STAFF REPORT: OCTOBER 8, 2025 MEETING

APPLICATION NUMBER: HDC2025-00249

ADDRESS: 6325 W. JEFFERSON AVENUE, AKA FORT WAYNE

SCOPE: REPLACE HISTORIC FENCE, RENOVATE PRIMARY ENTRANCE, SITE IMPROVEMENTS, REPLACE PARK SIGN

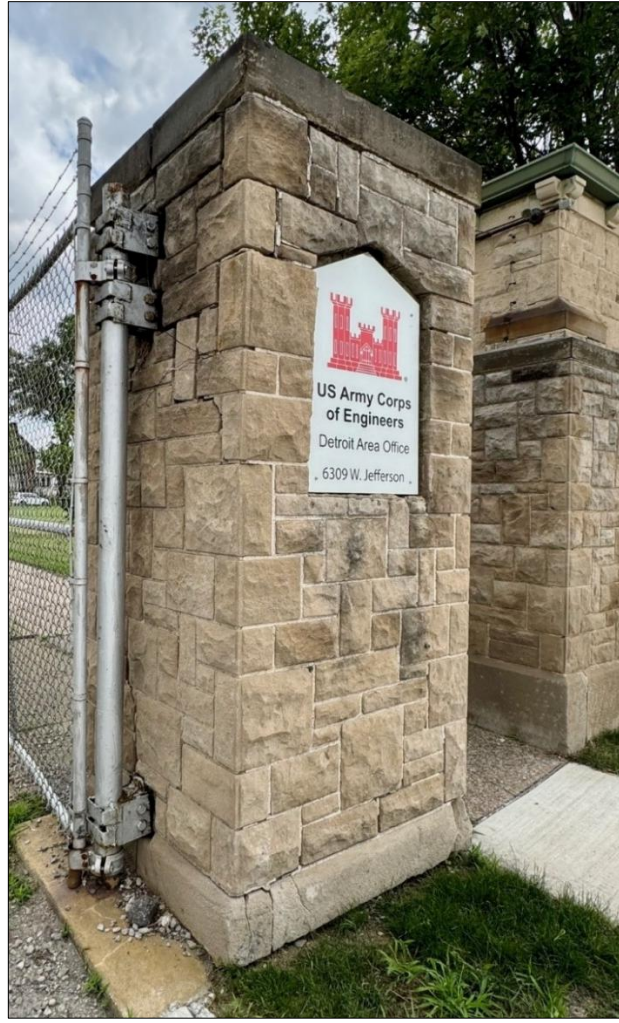
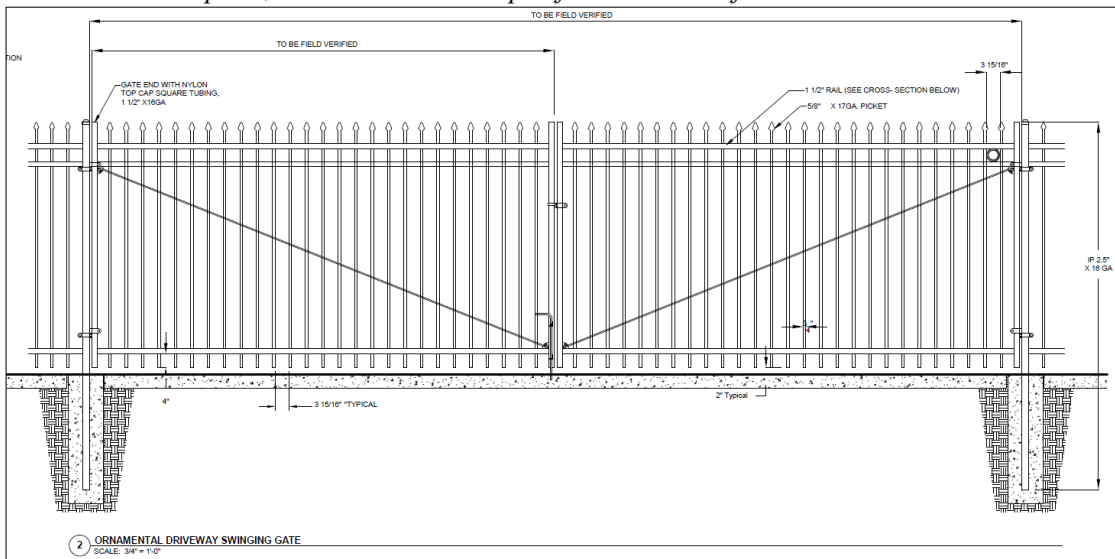
- Each pier has areas of missing mortar, cracked, dirty and/or stained stone. The applicant’s drawing, specifically Page A1.0, states the masonry cleaning and repointing of all failed masonry mortar joints will be consistent with the NPS briefs: “Cleaning and Water-repellent Treatments for Historic Masonry” and “Repointing Mortar Joints for Historic Masonry Buildings.”

- The existing chain link gates are not historic age and can be replaced. The selected iron gates offer a compatible design, material and color for this primary entrance. However, an installation drawing for the proposed iron gates is needed to confirm that additional holes will not be created to hang the new gates.

Above: The entry gate piers and sentry house have areas of missing mortar, cracked and discolored stone, as well as existing holes used for the installation of the chain link gates. Staff photos, July 17, 2025.

- Dimensioned drawings for the proposed gates at the east and west entrances will be submitted to accurately reflect their installation methods and locations at the stone piers.
 - Additional holes will not be created to hang the new gates, and
 - The drawings should show how any remaining holes will be addressed relative to the gate installations.
- Regarding masonry cleaning, the applicant/contractor will follow the HDC *Masonry Cleaning Guidelines* and a detailed scope of work, as identified in the guidelines, will be submitted to staff for review and approval prior to work taking place.

Guard House

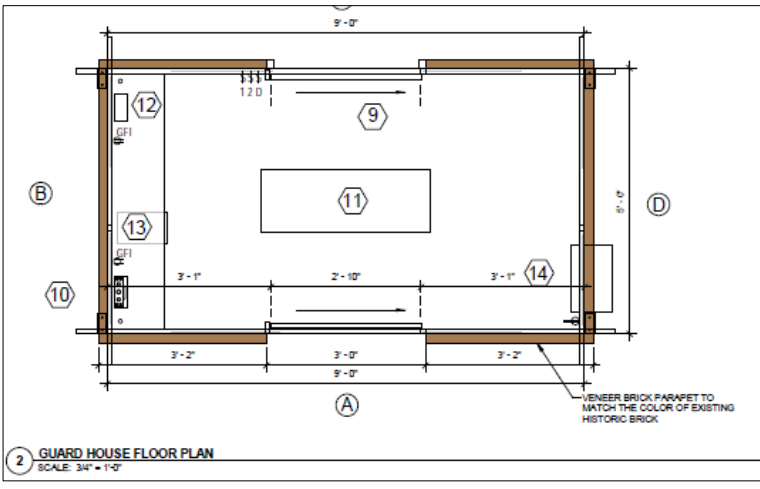
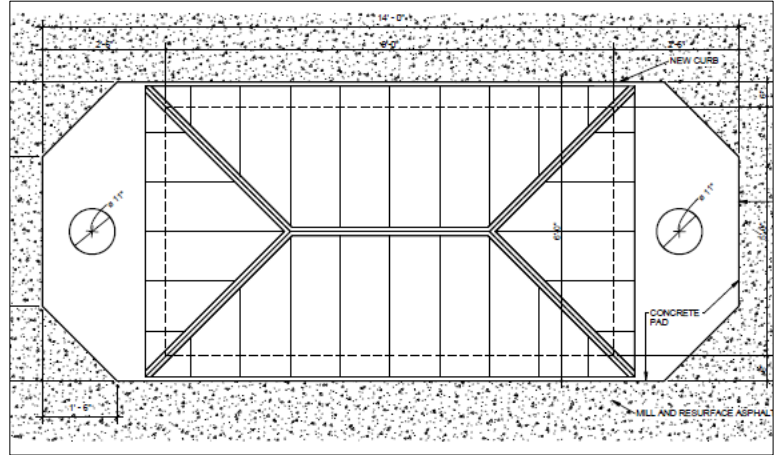
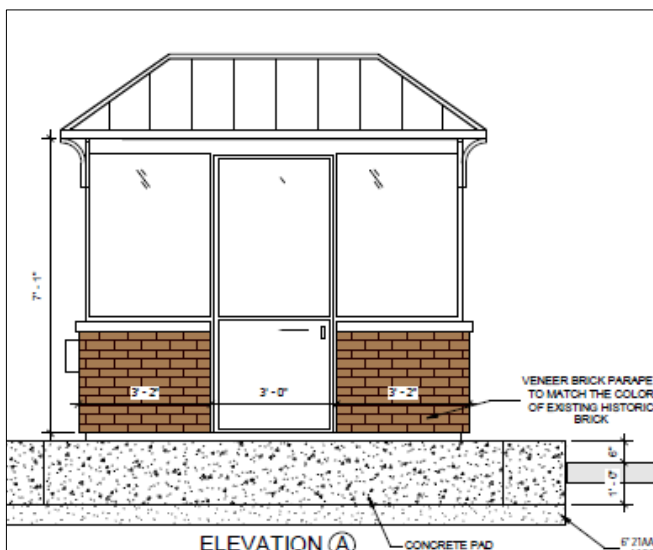
- The existing guard house, pictured below, was likely erected in the late 1990s or early 2000s as the location was moved to the center of Brady Street. The previous guard house had been placed in the lawn area, close to where the arrow is positioned. This guard house has no historic significance and can be replaced.
- The new guard house will be in the same location and will rest on a similarly designed/sized concrete pad with a bollard at the front and rear walls. Its design is similar to the existing structure - the brick base, mostly transparent glass upper walls and metal hip roof is a compatible, unadorned utilitarian design that will not visually conflict with the surrounding historic masonry structures.

Below left: Elevation drawing of the east or west wall. Note states: "Veneer brick parapet to match the color of existing historic brick."

Removal of existing sign and flags /
Installation of new sign and flags

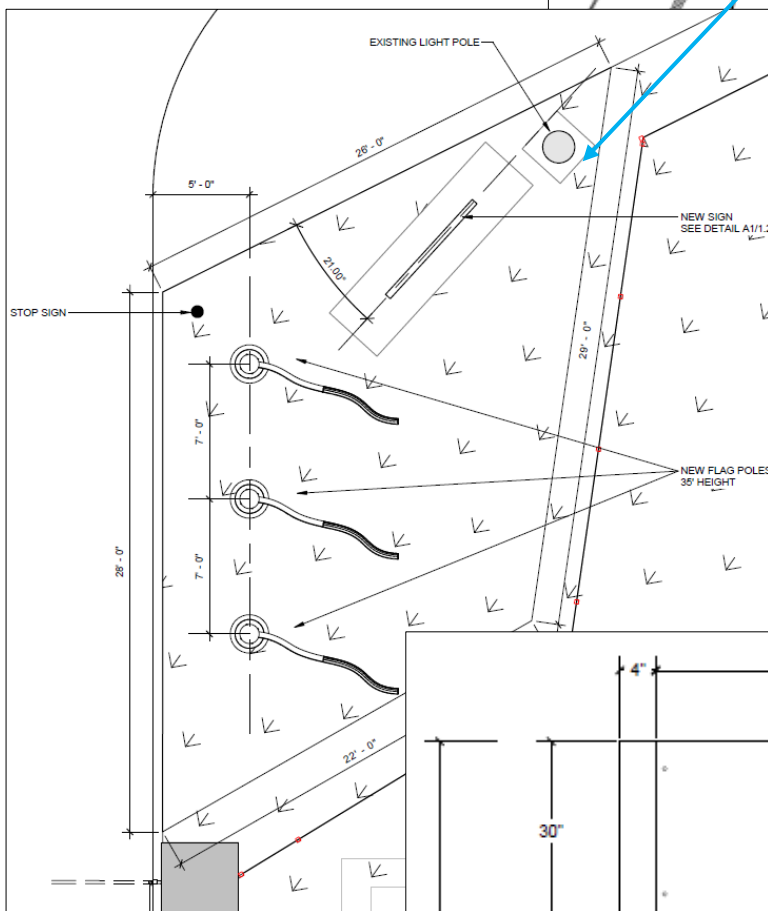
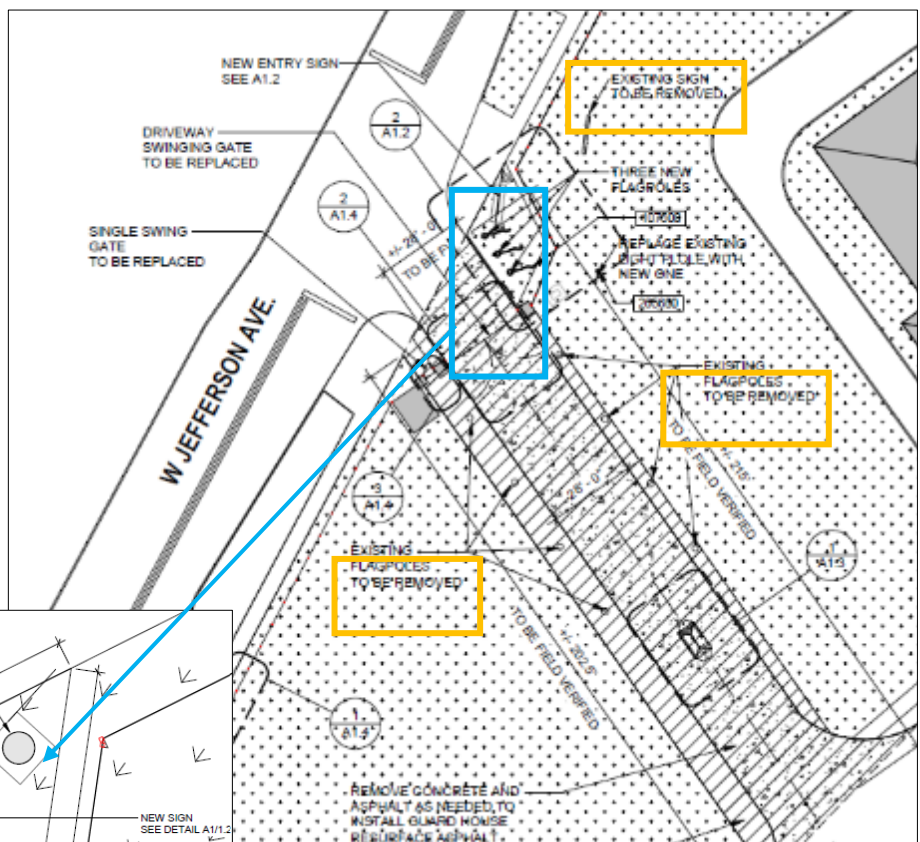
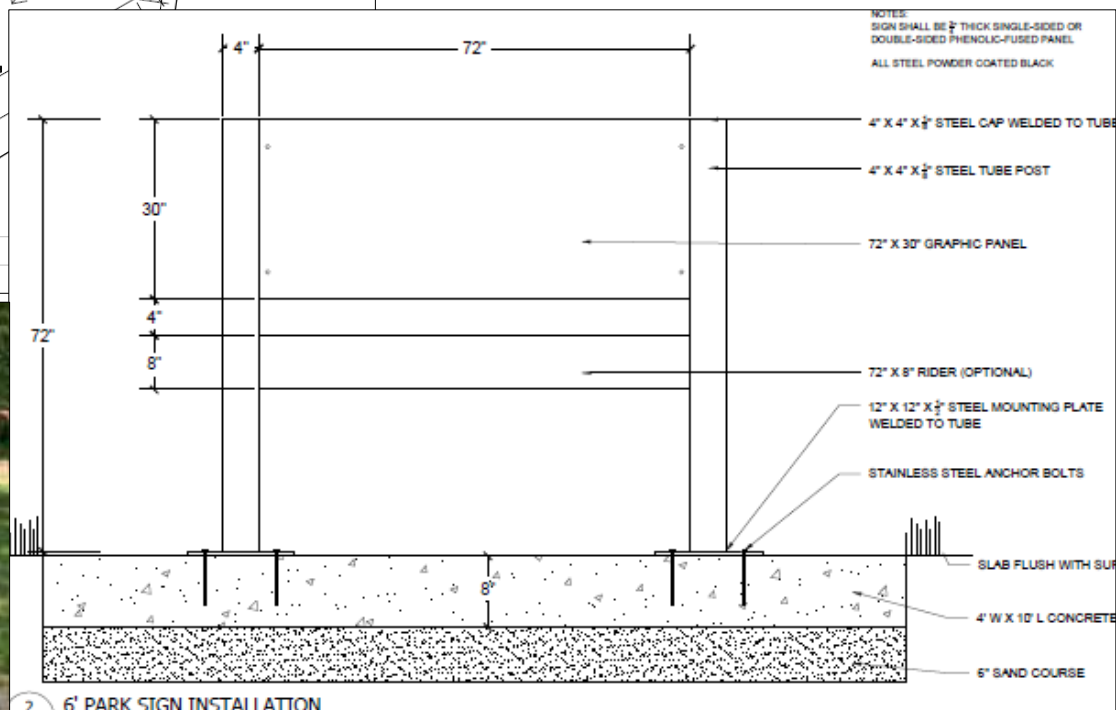
- The existing flag poles, flanking Brady Street will be removed. They are not historic age and were installed in the late 1970s-early 1980s.
- The existing entrance sign, installed ca. 1984, will be removed.
- The concrete drive and walkways will be replaced with new concrete drive and walkways.
- A new sign and set of three (3) flags will be located outside the entrance and perimeter fence.

Existing conditions of fence

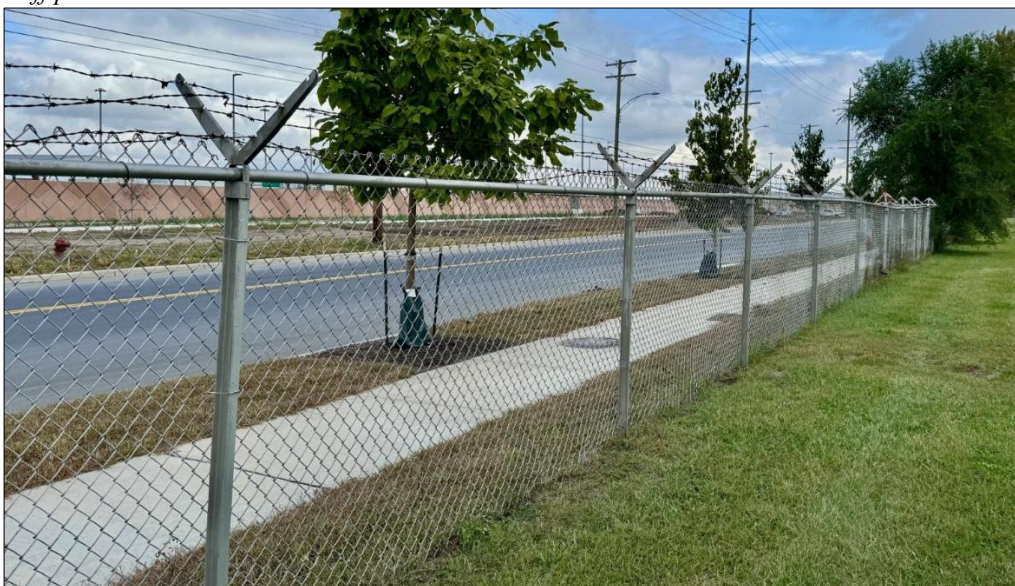
Interior view (looking northeast towards W. Jefferson) of the 1860s entry walls shows how the non-climbable fence was installed on top of the stone walls at the east entry gate, and the existing chain link gate retains barbed wire at the top. Staff photo, July 17, 2025.

Fence between Cram and Brady streets; the visitor parking lot is visible through the fence.

- However, there are occasional areas where the fence needs attention due to missing or leaning posts, as well as one instance in which a tree grew into and ultimately around/through the fence. Also, some of the toppers have surface rust, which could be eliminated by gentle surface repairs/scribbling/refinishing.
